Memorial Drive Elementary

Project Advisory Team
Meeting #7
June 14, 2022

MEMORIAL DRIVE
NATIONAL EXEMPLARY SCHOOL

Brick Color = “Study Tonal Range”

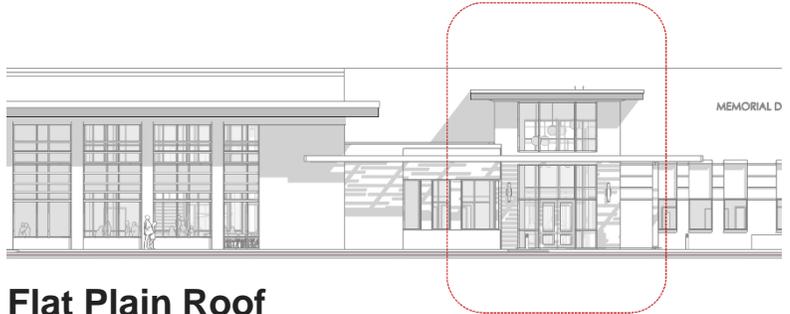
- Lighter in color – Similar to stone color
- Explore other brick color options

1 Design Options at Front Entry

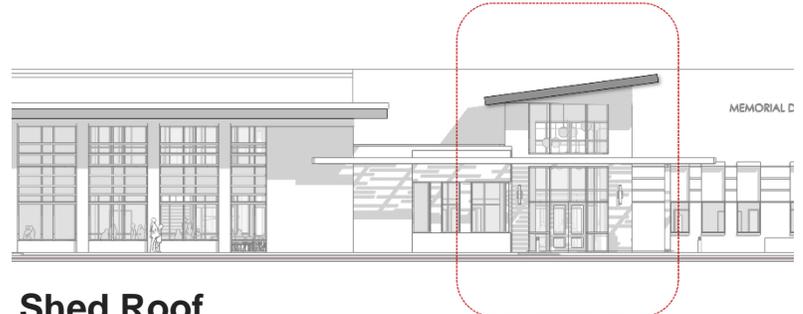
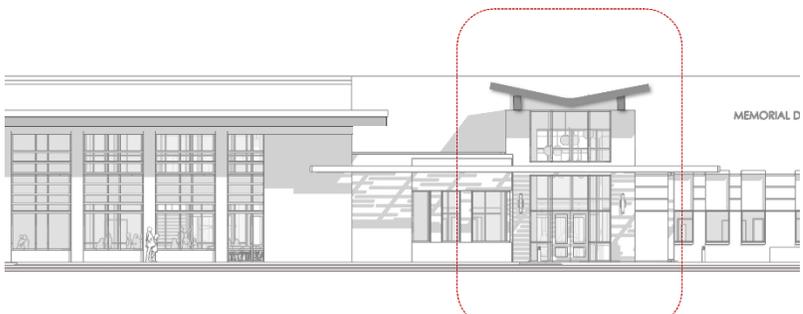
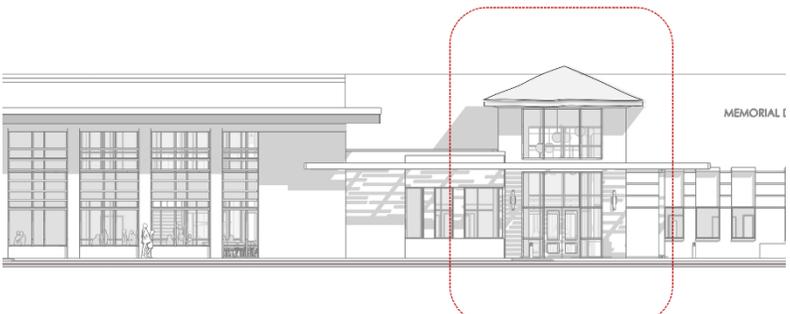
- Entry appears dark - Building feels muddy + Lacks contrast
- Somewhat heavy feeling under entry canopy - Deep shadows
- Needs to be light and bright - More prominent entry
- Option for a more vertical expression for primary entry
- Feels boxy, options for roof shapes at both the library and entry

- Lighten entry canopy
- Give entry greater definition
- Explore more of a vertical expression for entry
- Explore a more dramatic shape for the roof line
